Jitter corner in 100GBASE-ZR

Piers Dawe

Nvidia

March 2021

Apparent SJ after EVM sampling

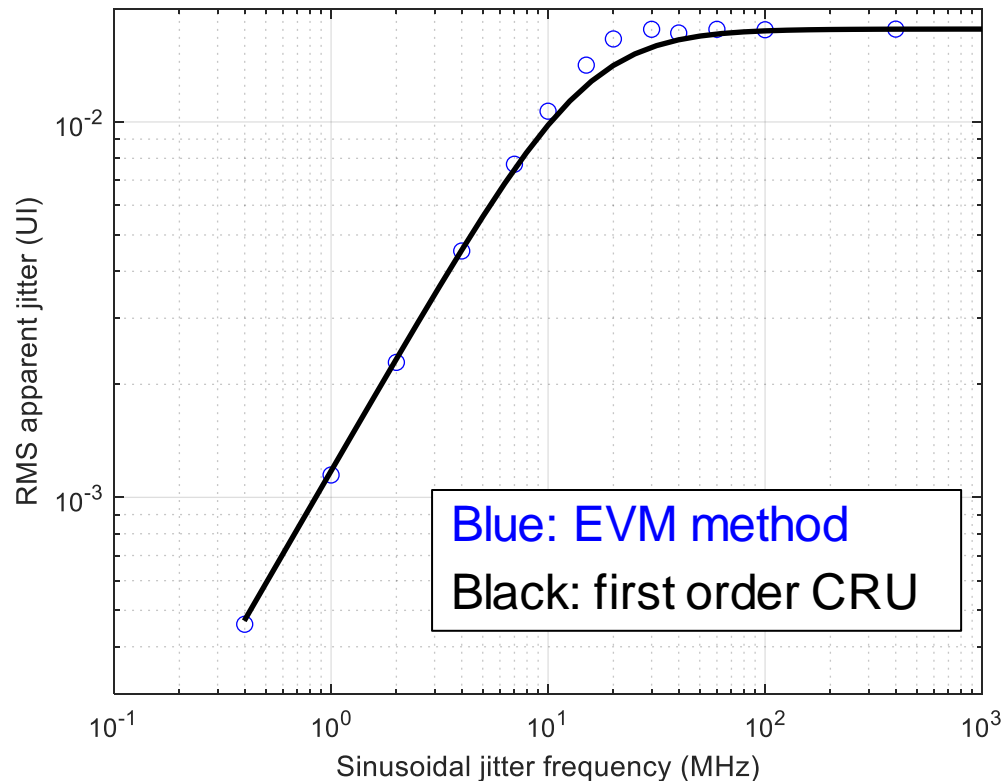
- Effective jitter corner of the default EVM method is 15.2 MHz
 - based on the LF roll-off, which is first order (20 dB/decade). The -3 dB point is 12.8 GHz
- Either way, it's far too high for a DSP receiver, and transmitters can do better
